Site-and-soil evaluation Beasley Road Sunrise Estates

TECHNICAL ASSESSMENT OF PROPOSED DEVELOPMENT AGAINST RELEVANT PROVISIONS OF THE NORTHERN TERRITORY PLANNING SCHEME 2020

Proposed Planning PA2026-0137 subdivision
NT Portion 07860 – 745 Edith Farms Road, Edith NT 0852

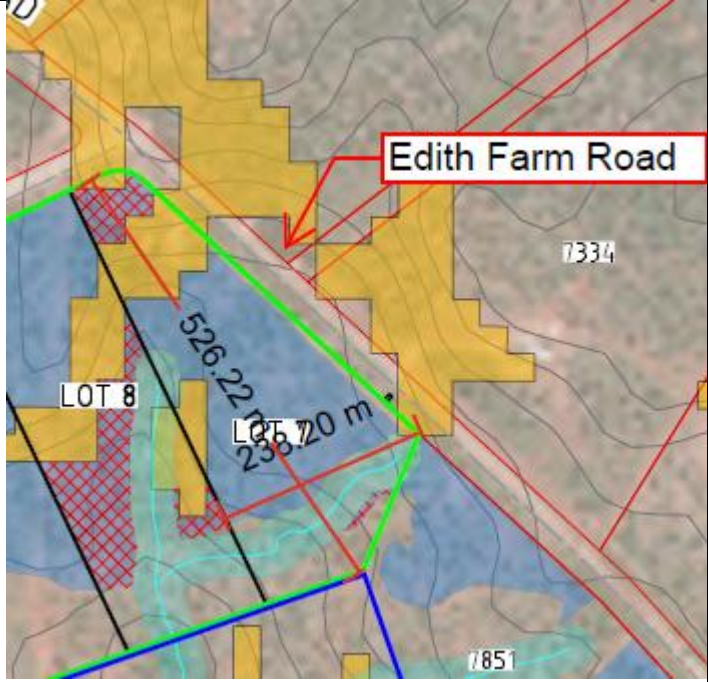
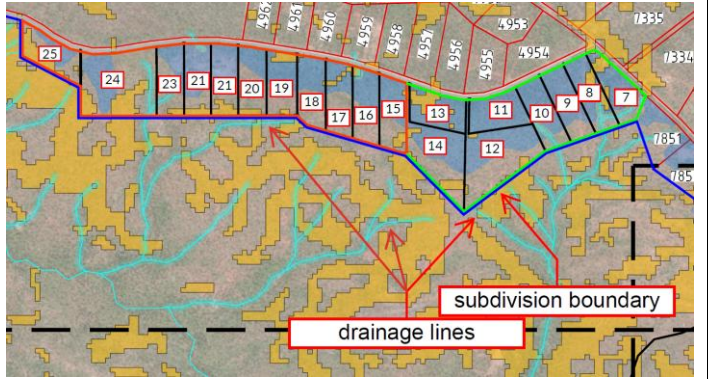
Lot 7 has a (maximum) depth of approximately 526.22m and a (maximum) width of 238.2m which equals a simplified ratio of approximately 2.21:1 (or 4:8.84 if Edith Farm Road was counted as the primary street – image below).
